June 8, 2026

2025-CRW-1019

**Re: Addendum No. One (1)**  
Snow Removal Equipment (SRE) Building  
3-54-0003-087-2025 (Design)  
3-54-0003-XXX-2026 (Construction)  
West Virginia International Yeager Airport (CRW)

DETAILS

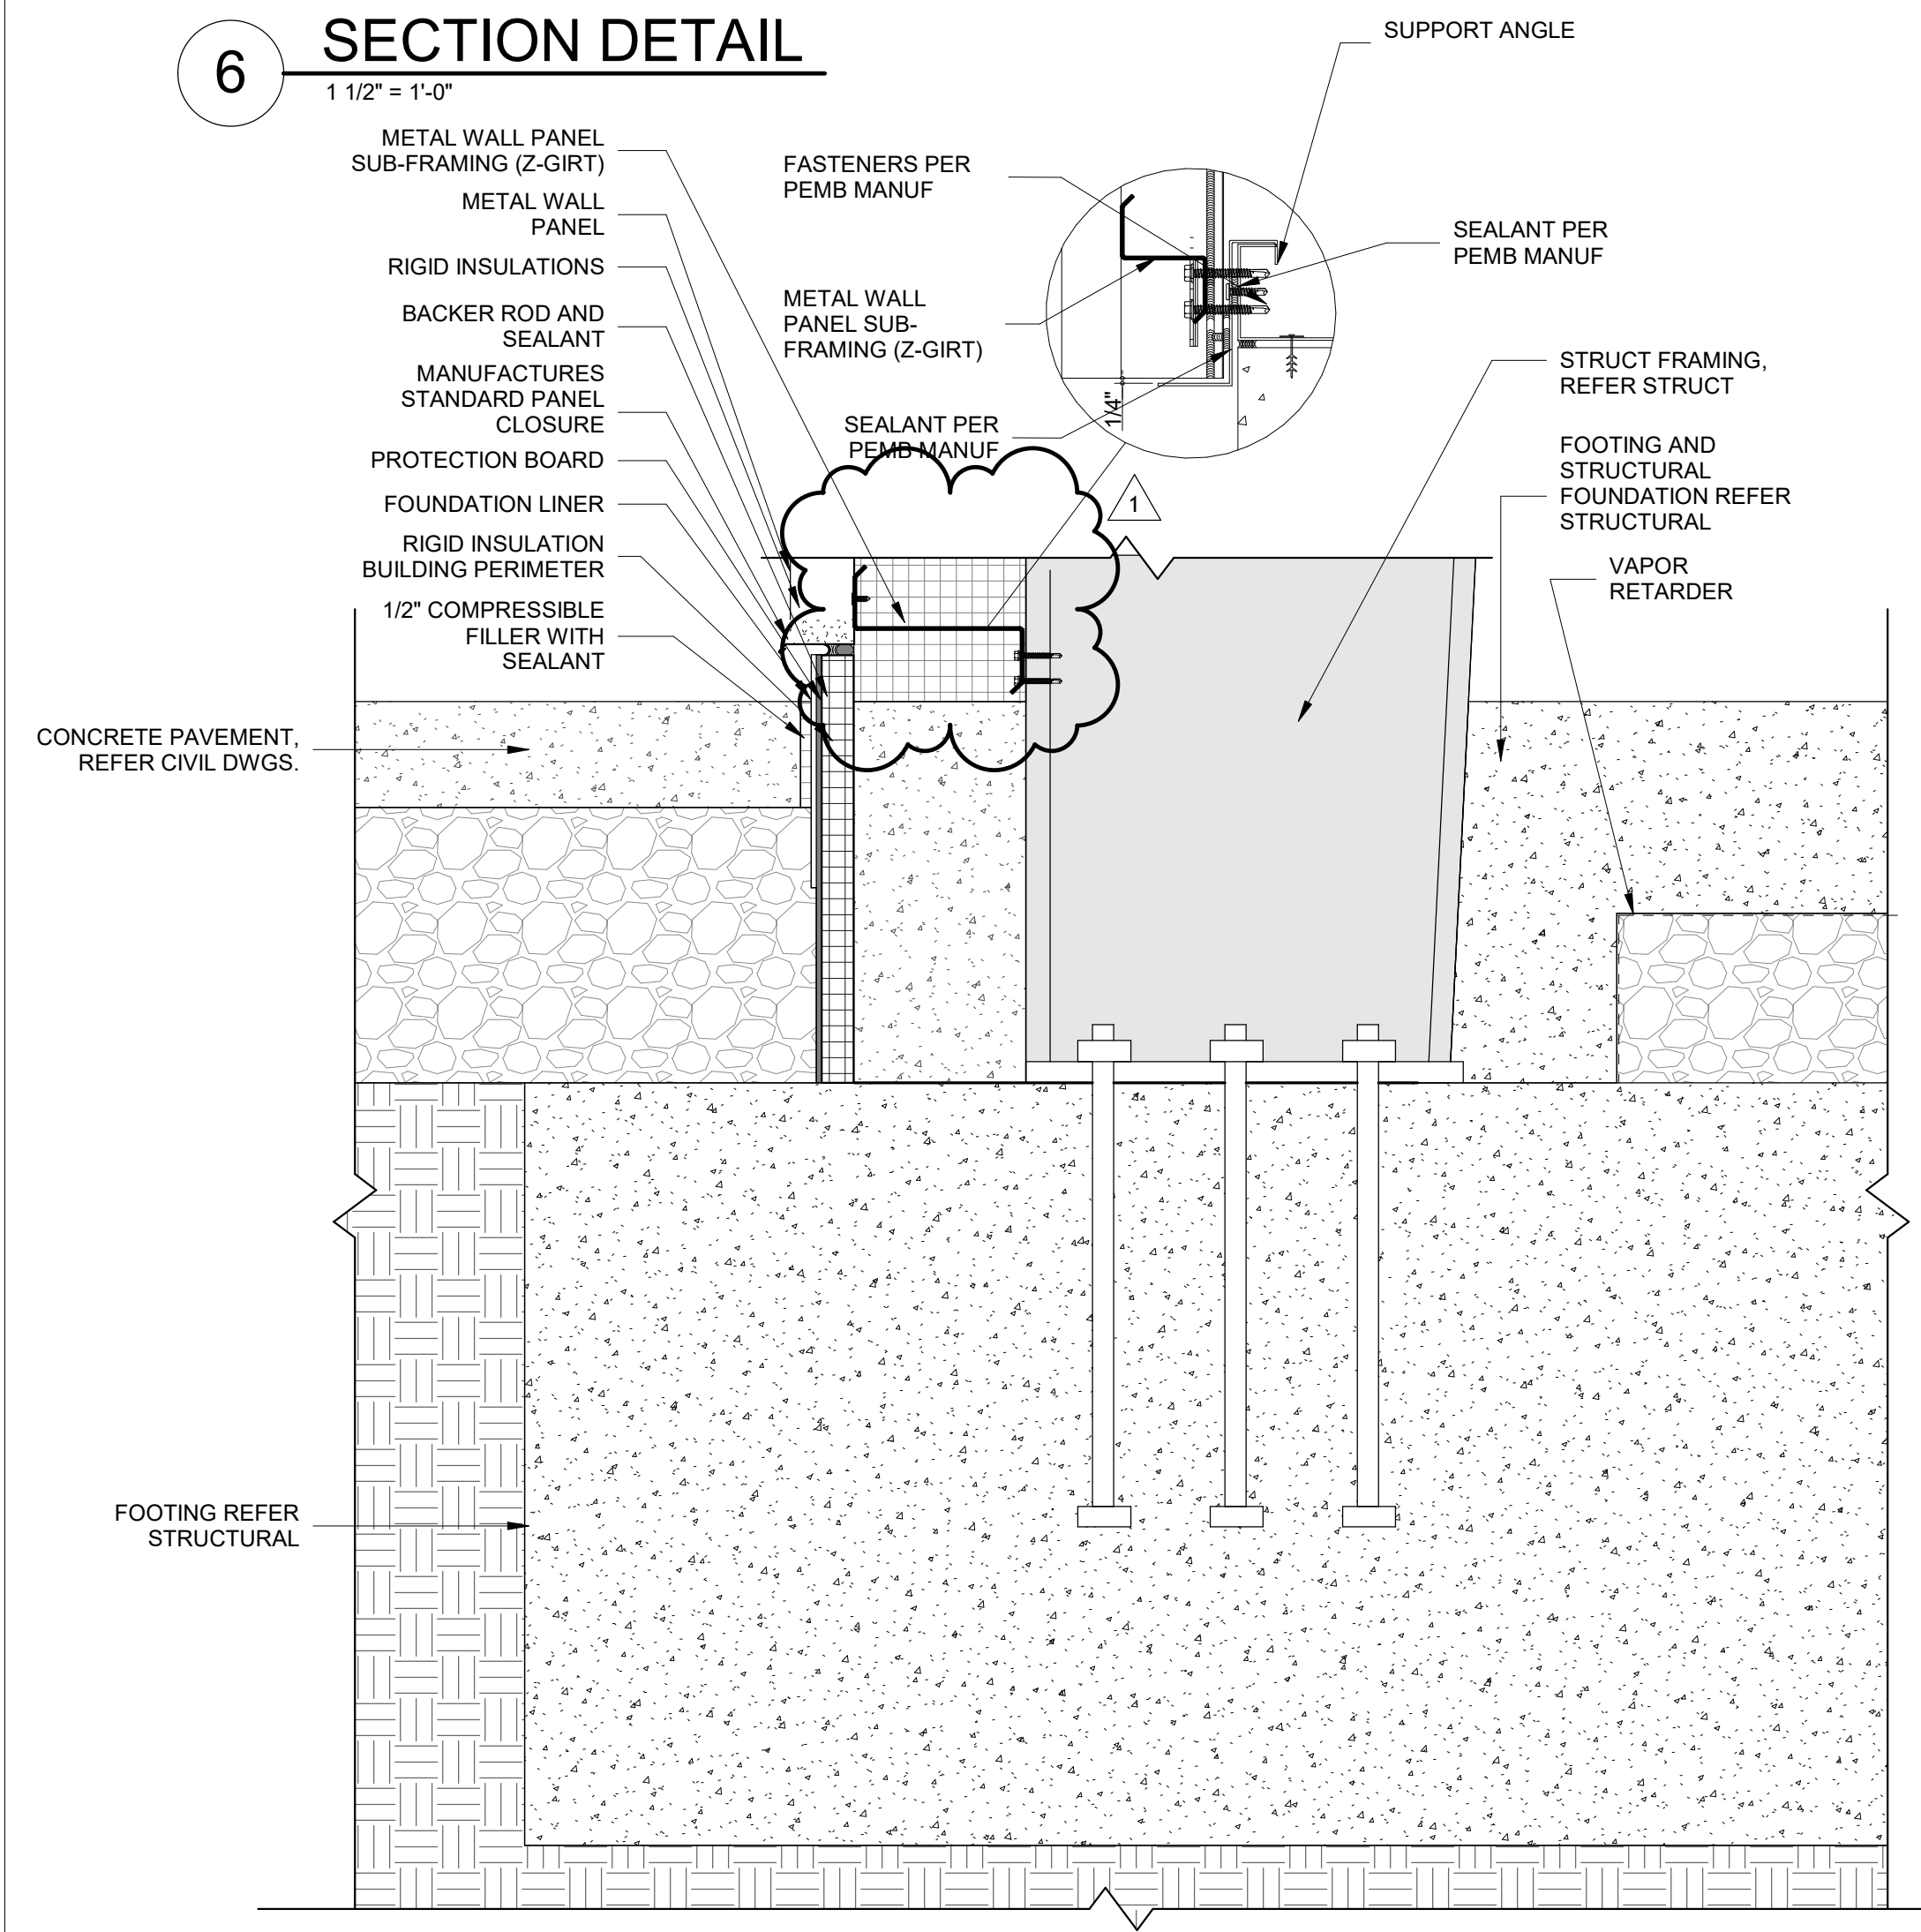
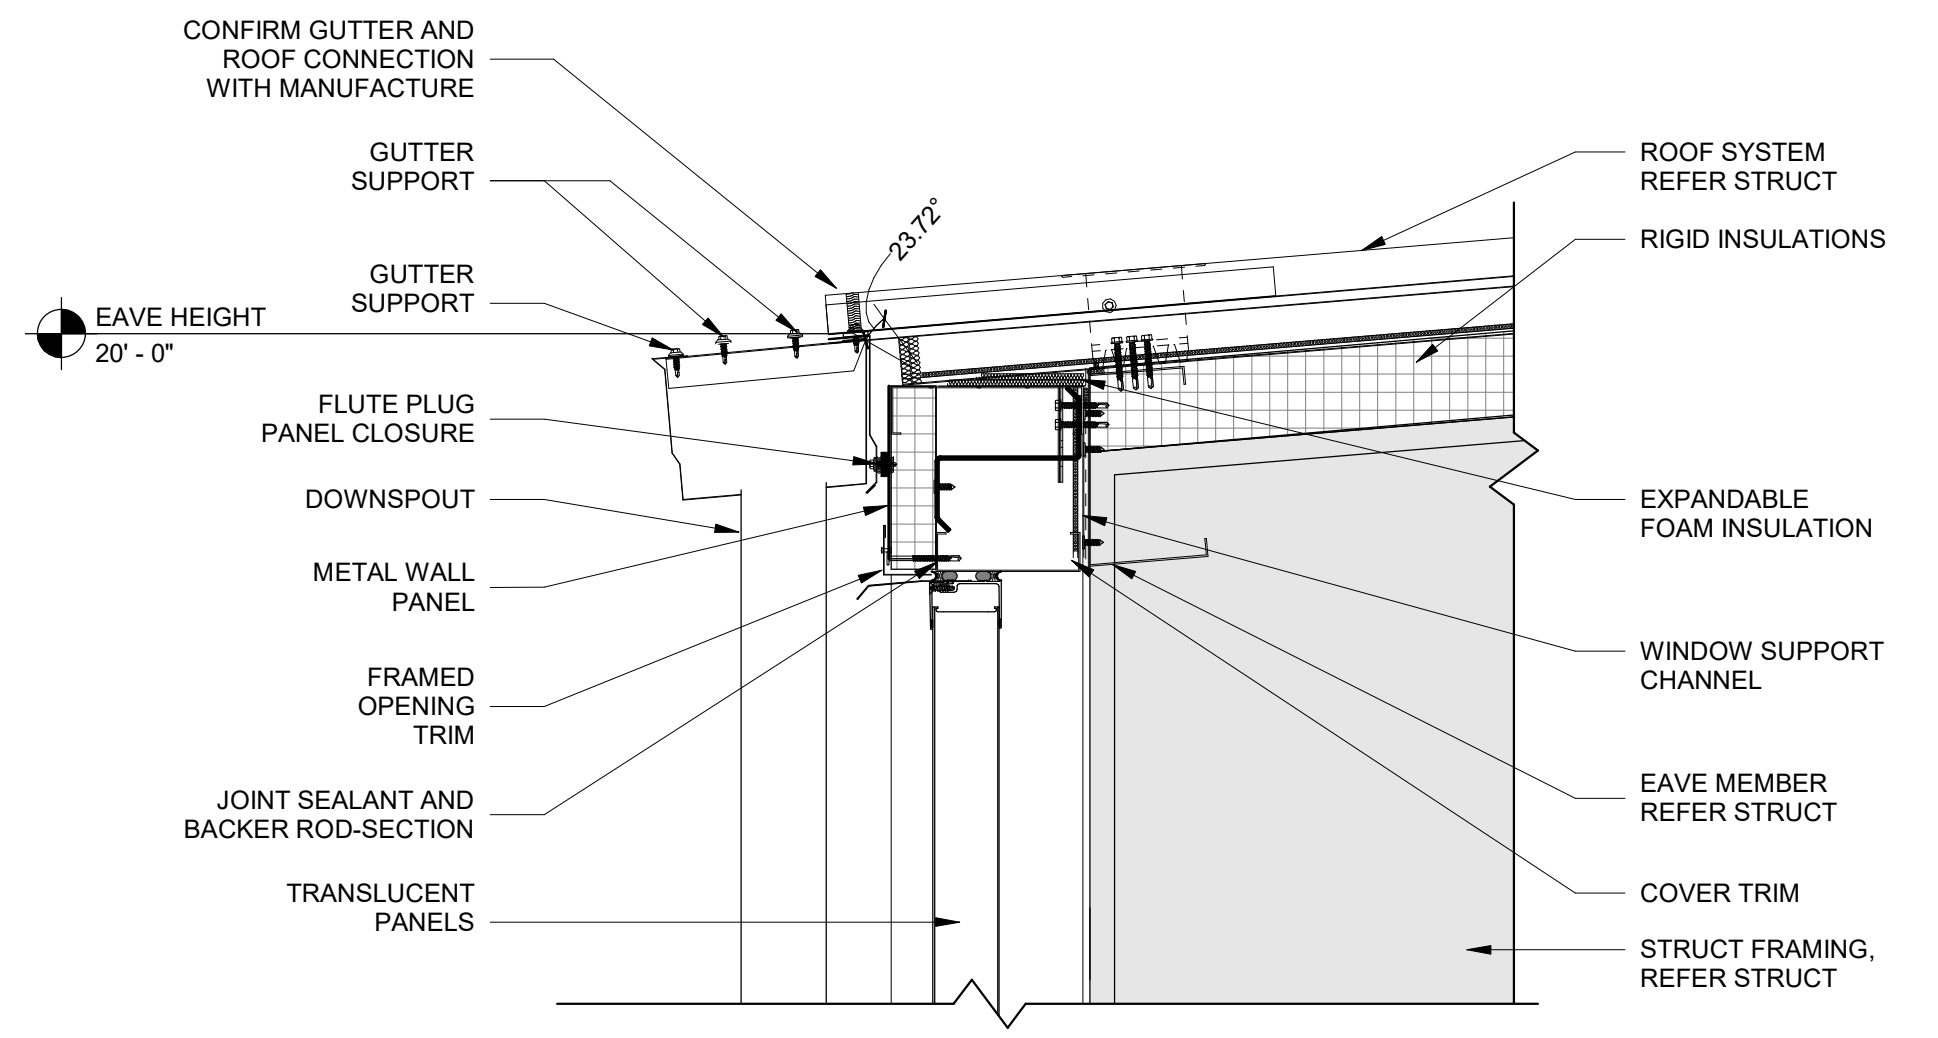
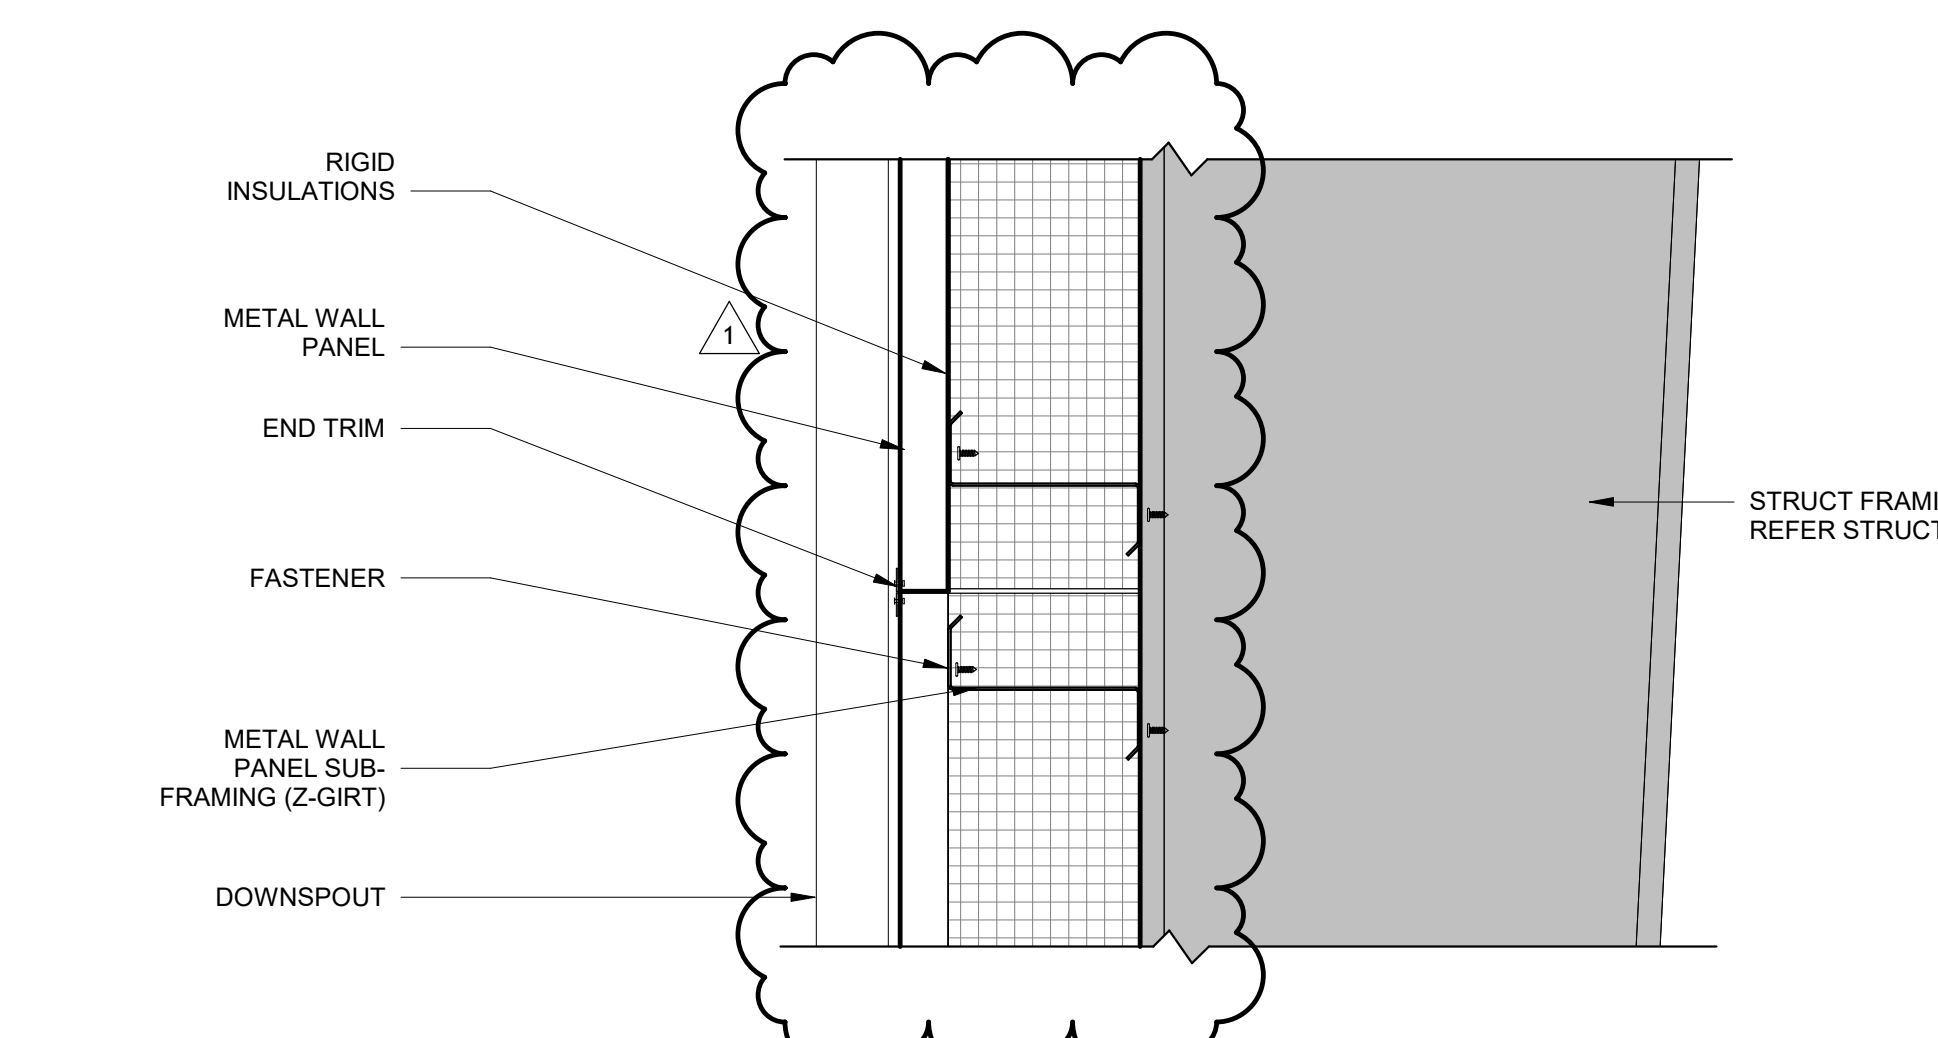
- 1.17.1 **REVISE** Details to show base bid with Metal Panel & Interior Insulation
- 1.18 **REVISE** Drawing No. GC200
- 1.18.1 **REVISE** Major work Items/Suggested Sequence of Construction "Install Drainage Pipes, Floor Drains, Cleanouts and Headwall" to read "Install Drainage Pipes, Inlets and Headwall"

**Q55.** A501 – Detail #6:

**A55. Refer to revised Drawings A303 and A501, added specification section 012300 – Alternates, and revised specification section 133419 Metal Building Systems.**
